Process Sheet

Drawing Name : ARM EFFECTIVE 07.46.65 AUTH

: CU-DAR001 Dart Helicopters Services

Drawing Number Project Number - D3560 REV.B · N/A B

D3560-041 ARM WELDMENT (SHOWN). D3560-042 ARM WELDMENT (OPPOSITE)

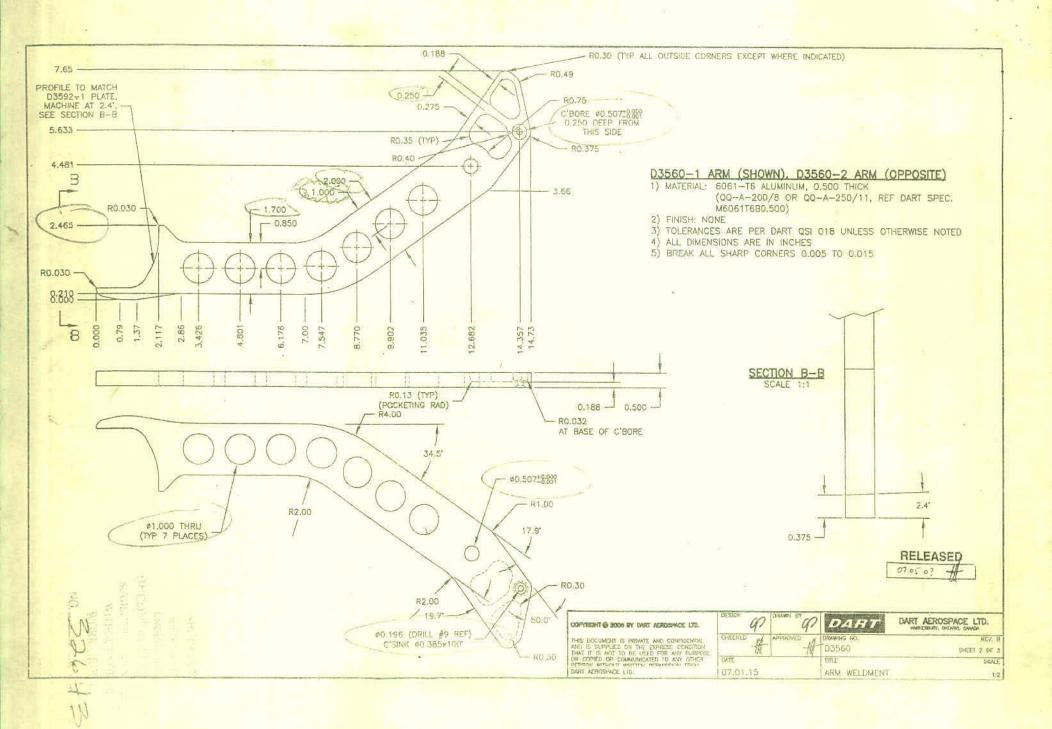
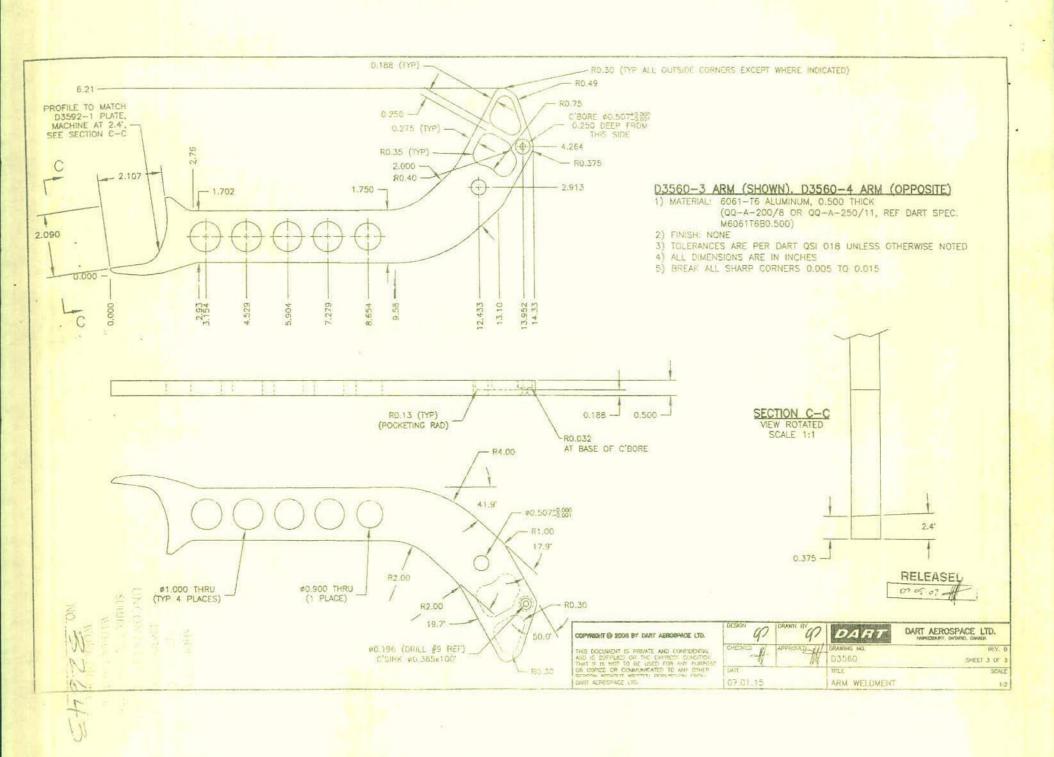
For the D3562-041/-042 step weldment, as discussed. They want to switch from Sikaflex to Magnabond, and powder coat after final assembly.

As part of this change, the D3560-XX arms won't be powder coated, and the D2808 Bushing won't be assembled until after final assembly of the step weldment.

Since this is the first time trying this, we will ensure that the steps are checked after powdercoating in case the Magnabond doesn anything unexpected (eg. bubbling). If we see anything suspect, we will assemble them the old way.

As we have discussed previously, this is acceptable as long as the Magnabond doesn't break down.
